Re: NYSRC Comments on CAC's Draft Scoping Plan

These comments are submitted on behalf of the New York State Reliability Council ("NYSRC") as requested by the Climate Action Council (CAC) and regarding the CAC's Draft Scoping Plan.

**Figure 30. Installed Capacity in 2050, All Scenarios<sup>31</sup>**

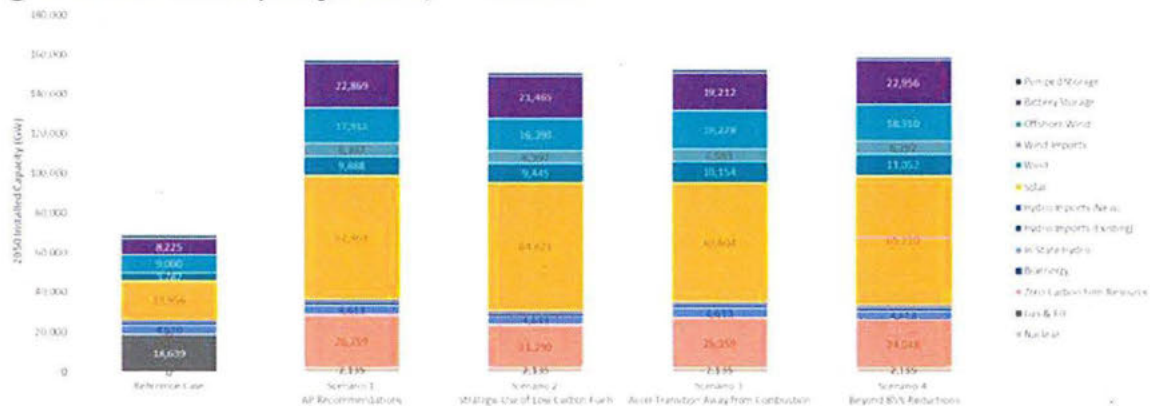
It is noted that the CAC’s Draft Scoping Plan uses NYSRC’s resource adequacy criterion but employs an alternate methodology and data to determine the amount of installed capacity and IRM necessary for reliable operation. At this point NYSRC cannot confirm the future resource requirements in CAC’s Draft Scoping Plan. However, scenario studies performed by the NYISO under NYSRC direction for the study period up to 2030 have indicated a similar increase in the capacity needed to comply with reliability criterion (the probability of the loss of load no more than in 1-day-in-10-years) as a function of increased penetration of intermittent resources.
